DESCRIPTION AND MAINTENANCE INSTRUCTIONS

ANTI-ICER PIPING INSTALLATION

Figure 1

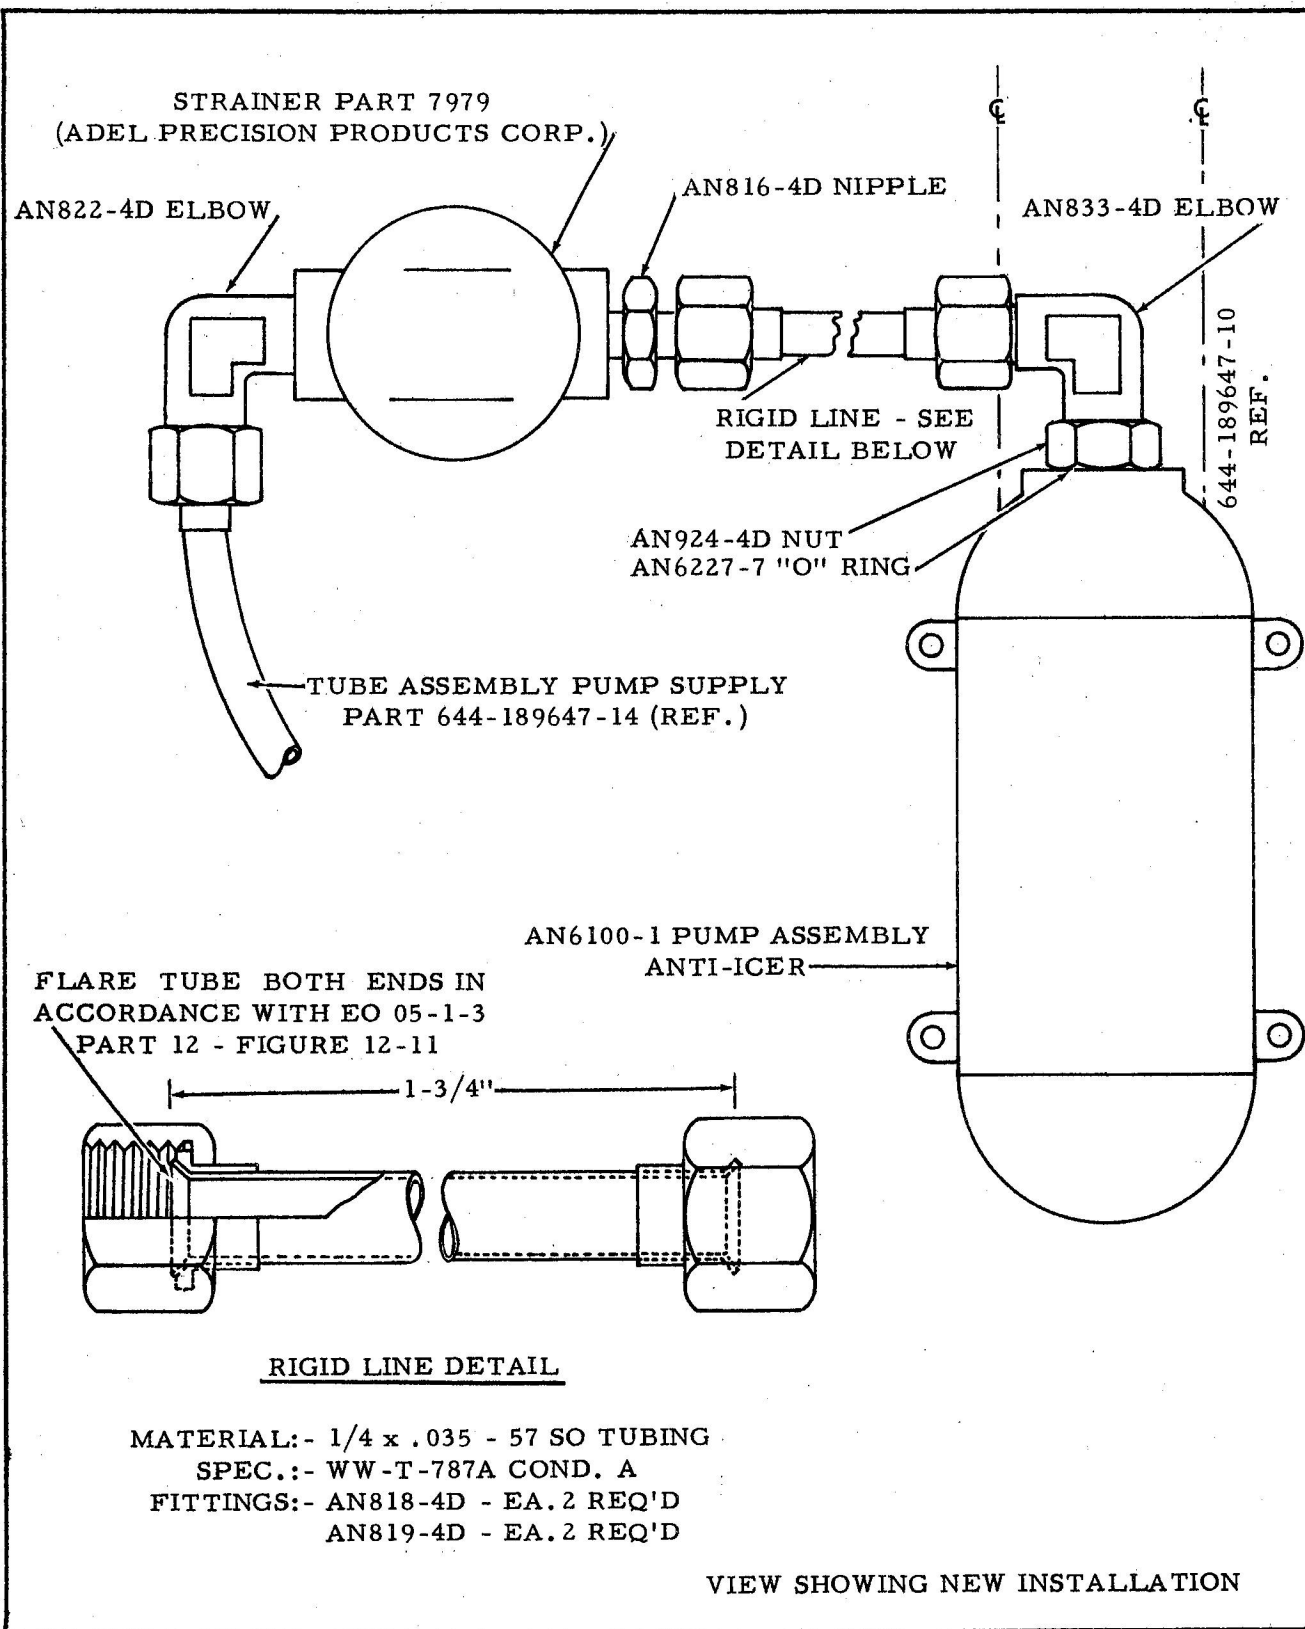
1 The existing anti-icer piping installation as detailed in EO 05-45B-4, Figure 53, is subject to leakage where the AN816-4D nipple is fitted into the AN927-4D elbow between the pump and the strainer. Outlined hereunder is a scheme whereby a short length of tubing is installed between the elbow and the nipple per-

mitting tightening of fittings without disturbing the position of either pump or strainer.

2 To overcome anti-icer system leakage as outlined above, fabricate and install a rigid tube assembly as detailed in Figure 1.
